MEMORANDUM

SUBJECT: EPA Position regarding the Lower Willamette Group's (LWG), Legacy Site Services' (LSS) and Union Pacific Railroad Company's (Union Pacific) June 22, 2016 Request for Dispute Resolution on EPA June 2016 Feasibility Study (Lower Willamette River, Portland Harbor Superfund Site, USEPA Docket No: CERCLA-10-2001-0240)

I. INTRODUCTION

II. LWG DISPUTE STATEMENT RESPONSE

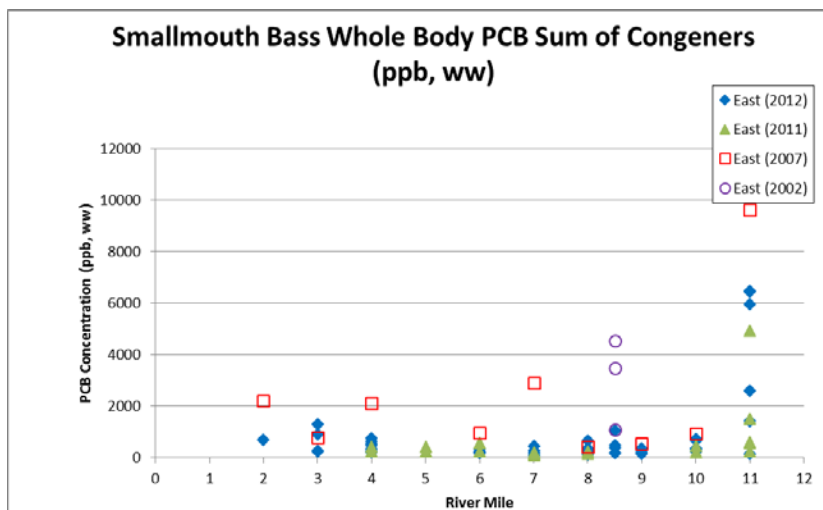
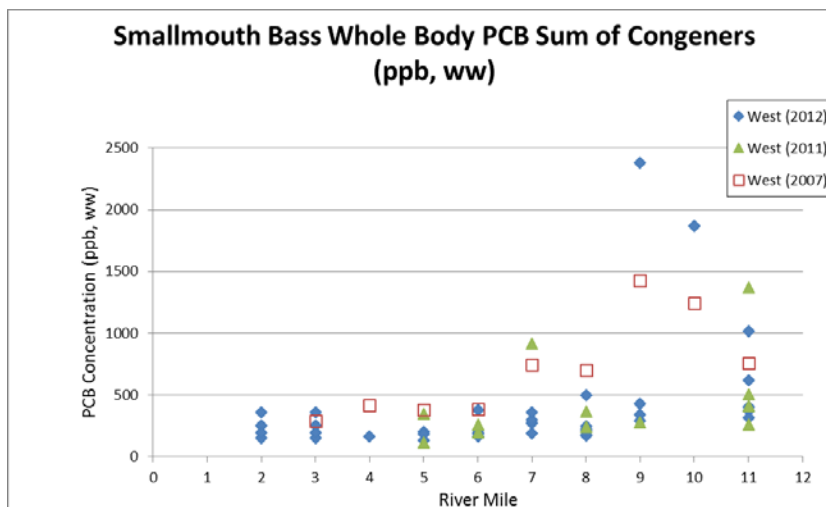
It is unclear if the sitewide total PCB spatially weighted average concentration (SWAC) values presented in EPA's FS included the RM 11.2 information acquired during the Supplemental RI performed in Segment 1 (River miles 9 to 11.7). This creates a significant problem in the comparison of subsequent surface SWACs because it suggests site conditions at the time of the RI were actually cleaner than they were. This makes the demonstration of significant sitewide natural recovery more difficult and inaccurate.

The 2016 FS clearly states in Section 1.3 that the data collected by the RM 11E Group were not included in the FS database. EPA reviewed the data prior to making the decision not to include in the database (although it is in the administrative record because EPA considered it) and determined that it would not significantly change the remedial footprints. EPA is unclear why the Respondent believes that the omission of this data would result in a significantly different SWAC since the data were collected to supplement the RI/FS data, not to recharacterize this area of the Site. EPA did not look at natural recovery Site-wide as the river dynamics are not consistent throughout the Site. EPA looked at natural recovery on a smaller spatial scale as discussed in Appendix D8 of the 2016 FS.
